TALLAWONG STATION **PRECINCT SOUTH**

ADDENDUM URBAN DESIGN REPORT

Rev. E_10.12.2020

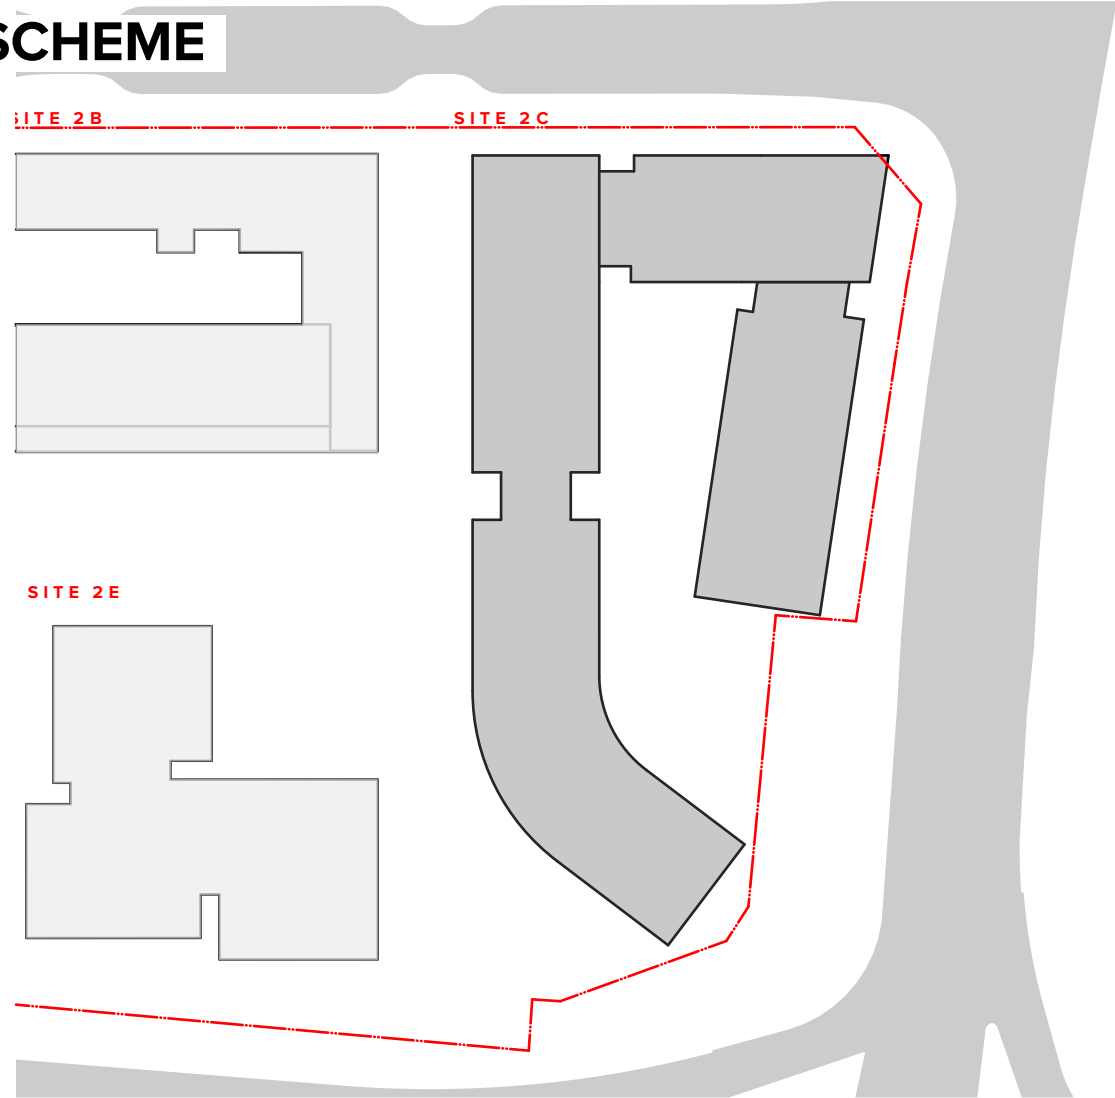
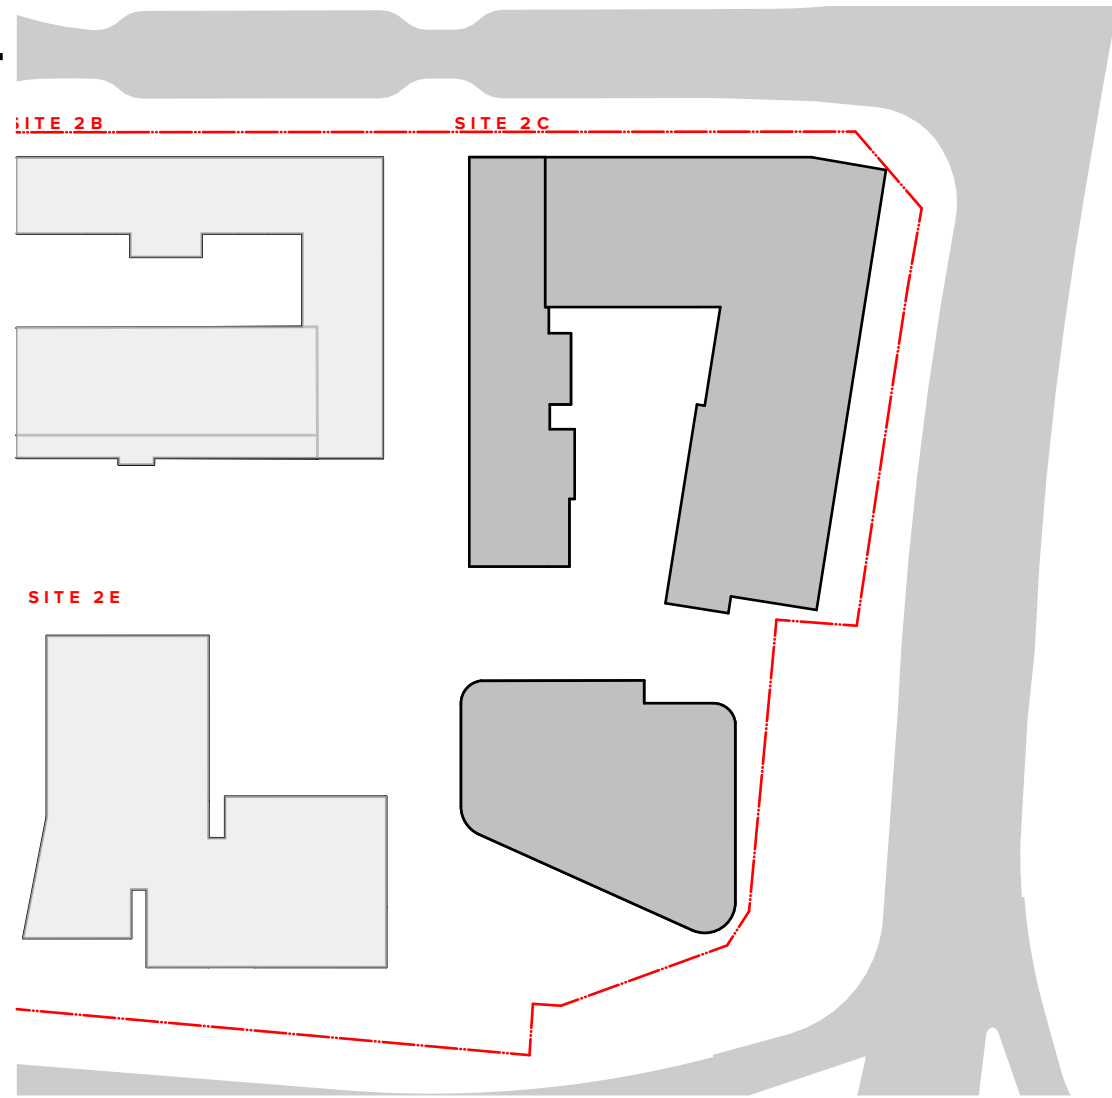
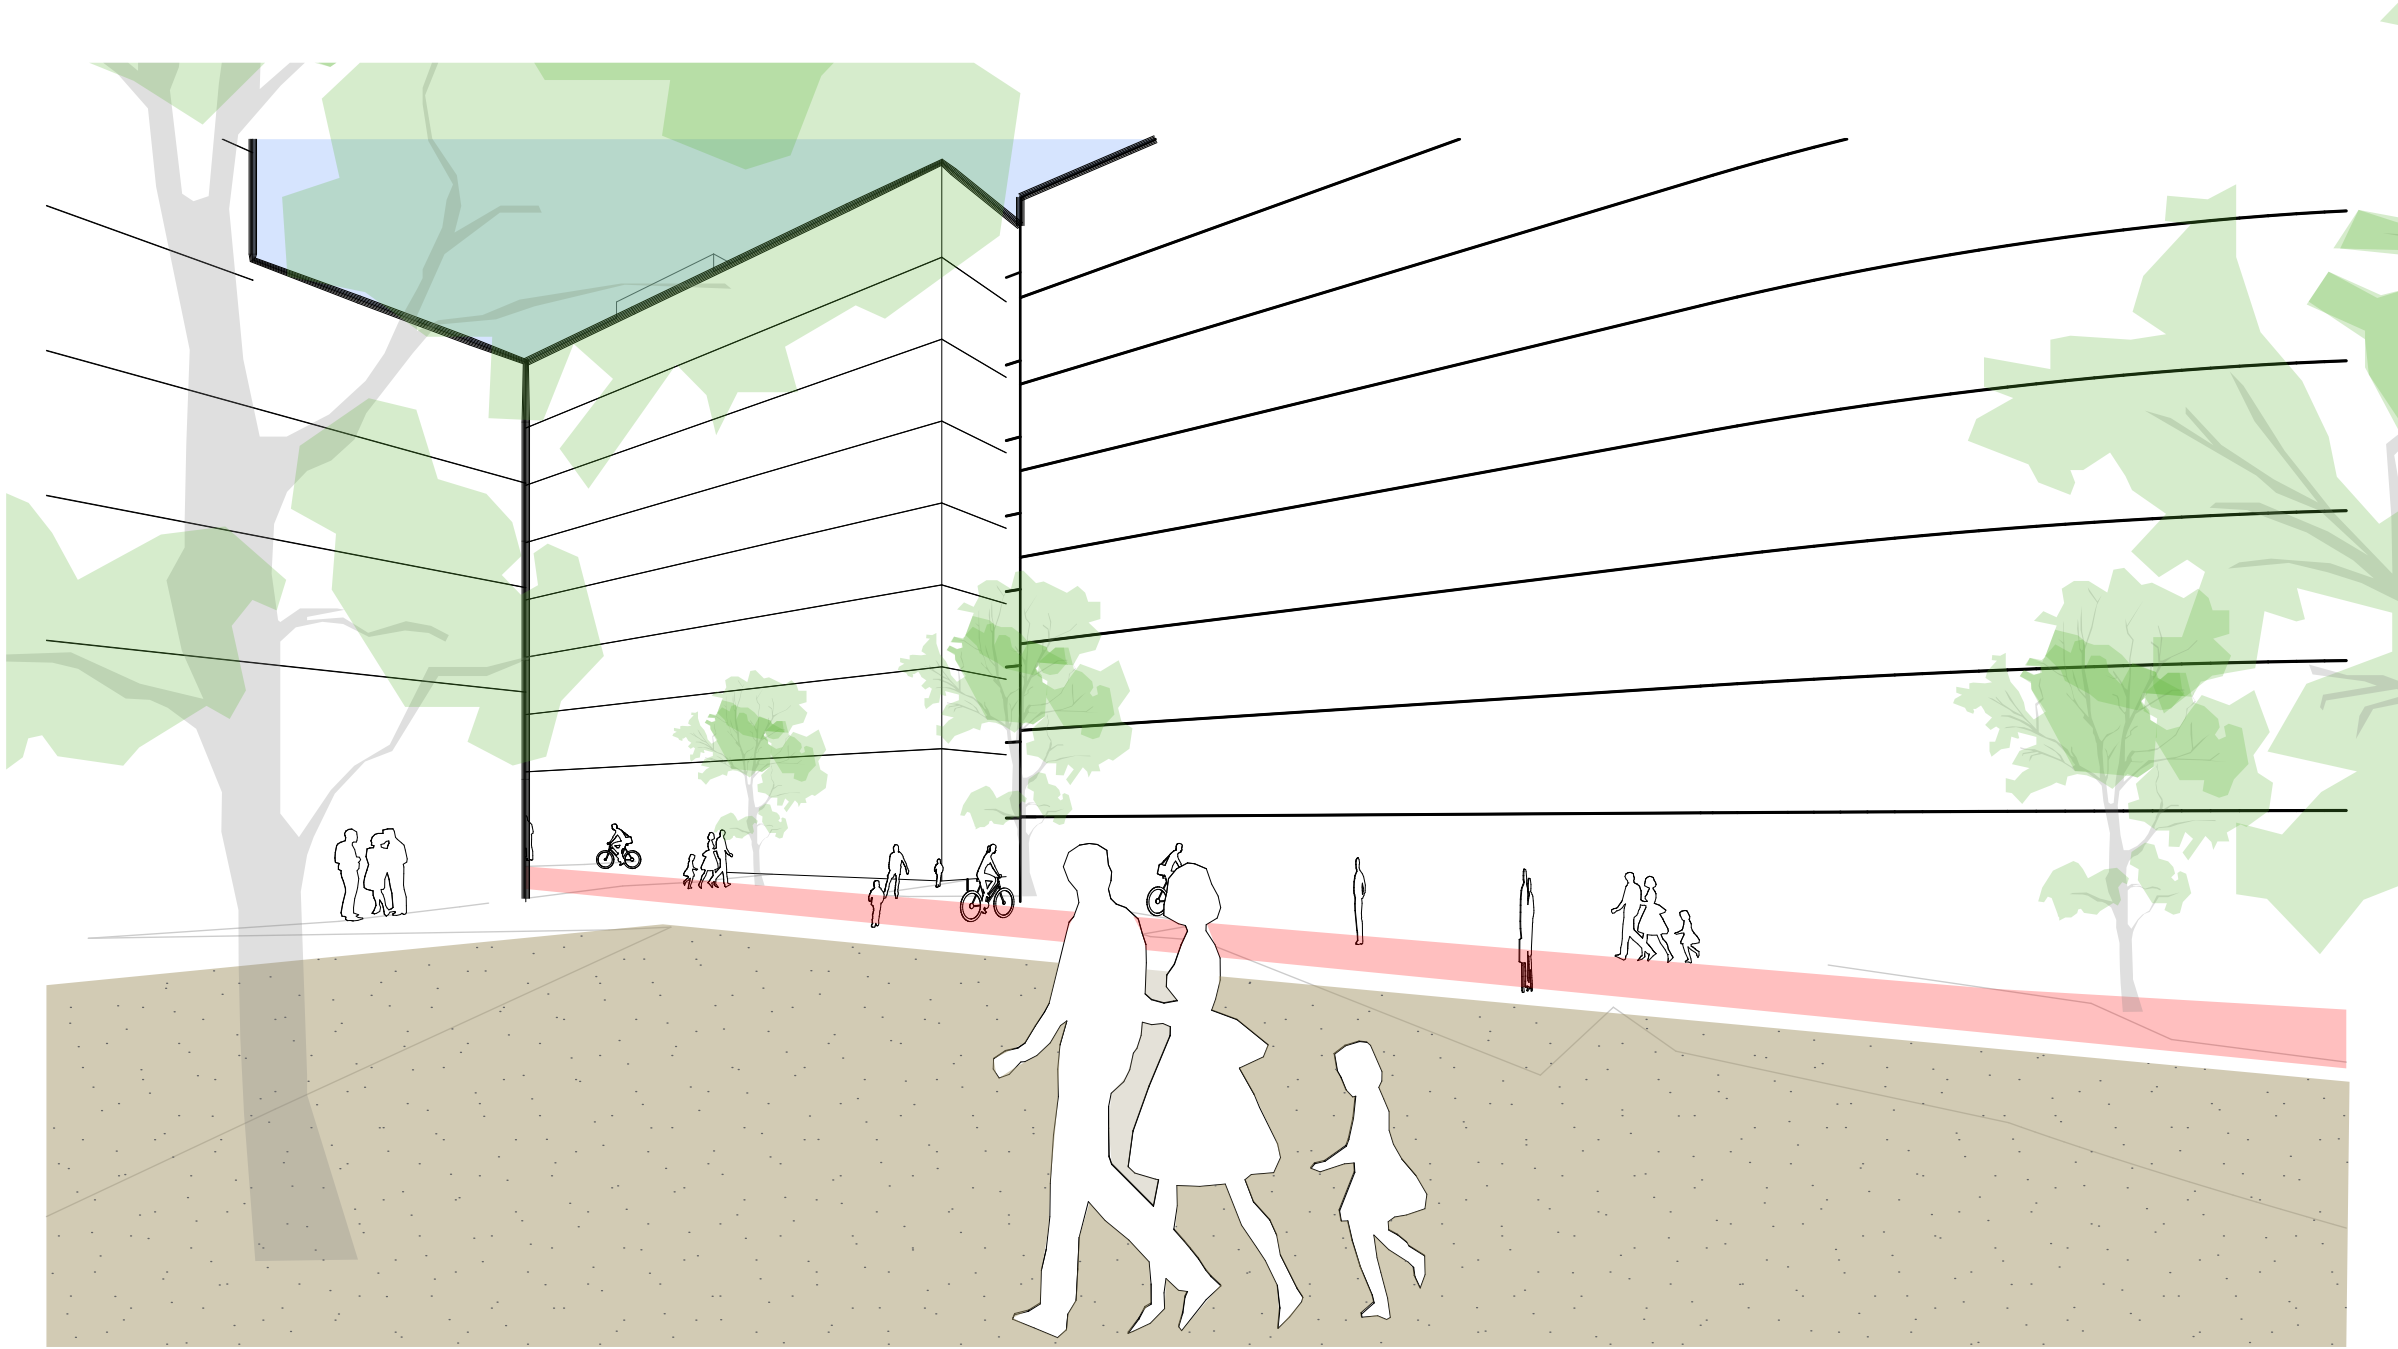
- ✓ Redistribute built form to maximise solar access to shareway/plaza
- ✓ Reduce building lengths to increase visual and physical permeability through the site
- ✓ Redistribute heights to provide a lower scale building interface along the length of the pedestrian boulevard
